PRODUCT/PROCESS CHANGE NOTICE (PCN)

PCN #: **A1410-03** Date: October 31, 2014
Product Affected: VFQFPN-64, VFQFPN-72
(Refer to Attachment 2 for affected part#)

PCN Type: Assembly Process Change

Figure1: Comparisons between Punch versus Sawn

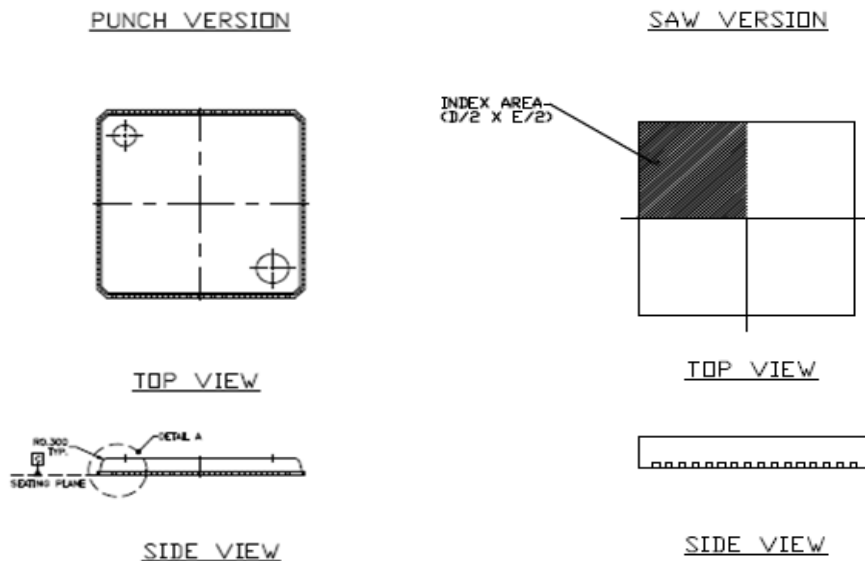
This notification is to advise our customers that IDT is converting from punch singulation process to sawn singulation process. There is no change in lead termination layout and dimension. As such, existing PCB land pattern design will not be impacted.

See Figure 1 for comparisons between punch versus sawn singulated part.
